### PLANNED UNIT DEVELOPMENT

STAFF REPORT Date: November 7, 2013

**DEVELOPMENT NAME** McGowin Park, LLC

**LOCATION** 1250 and 1400 Satchel Paige Drive

### SITE PLAN

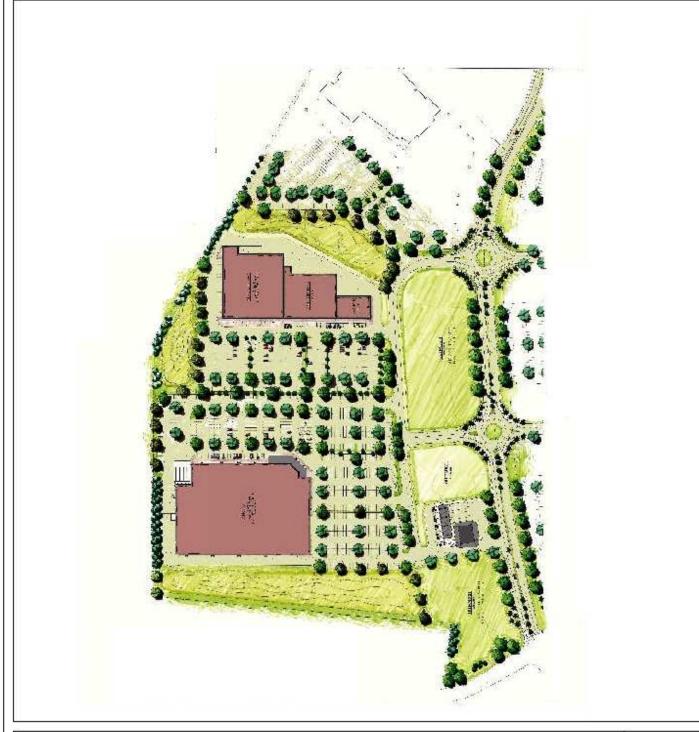
As stated above, the site has frontage on Satchel Paige Drive and Bolling Brothers Boulevard – both public streets. The development also proposes internal streets for access and circulation. During a predevelopment meeting it was discussed that all access streets are to be built to city standards. In addition, the construction of sidewalks along all street frontages, including private streets was discussed. It was noted that in some instances due to right-of-way alignment, sidewalks would have to be constructed on private property and that no easement would be required. While sidewalks are not reflected on the site plan, they will be required.

With regard to landscaping and tree planting requirements, specifics regarding landscape percentages were provided and meet or exceed the minimum requirements. However, it appears that when tree plantings were calculated, the I-65 frontage was not included – or at least not as frontage. While tree plantings are a critical issue, simply requiring compliance as a condition of approval (if approved) would address the issue, if any.

As illustrated on the site plan, there are to be several out parcels that are individual lots, and several that are "restaurant pads" on the larger, main lots. Therefore, subdivision approval will be required for all individual lots. Typically, the subdivision application would accompany the PUD application(s); however, in this particular case there are some finer details relating to specific locations of interior lot lines that are worked out. The subdivision application(s) will be submitted by the first deadline in December. Therefore, if approved, the approval should be conditional upon the completion of the subdivision process prior to the issuance of permits for actual building construction (Land Disturbing and Right-of-Way permits for road construction would be appropriate during this time frame).

The site plan does not depict the location of any dumpsters or compactors. The Zoning Ordinance requires that they be screened and that they be connected to the Sanitary Sewer. If locations impact traffic circulation or there are significant change to circulation when plans are submitted for permitting, new PUD application(s) will be required.

The dimensions of the drive-through lanes for the gas station are not indicated; but should be a minimum of 24' wide to allow for two way traffic, and meeting all other compliance standards for new construction.

- 9. all internal road construction (public and private) to be to City standards;
- 10. construction of sidewalks along all road frontages (public and private), due to right-ofway alignment, some sidewalks may have to be constructed on private property (easements shall not be required);

- 11. limited to the free-standing sign package as described in the application (and submitted for preliminary review);
- 12. full compliance with landscaping and tree planting requirements including I-65 frontage in all calculations;

- 13. illustration of dumpster and/or compactor locations, screening, and notation of connection to sanitary sewer on the final PUD site plan, as well as on all site plans for permitting;

- 14. drive-through lanes for the gas station to be a minimum of 24' wide to allow for two way traffic;
- 15. lighting of the site must comply with Sections 64-4.A.2., 64-6.A.3.c. and 64-6.A.8. of the Zoning Ordinance;

- 16. submission of a revised PUD site plan depicting compliance with all conditions prior to the issuance of permits for building construction; and
- 17. full compliance with all other municipal codes and ordinances.
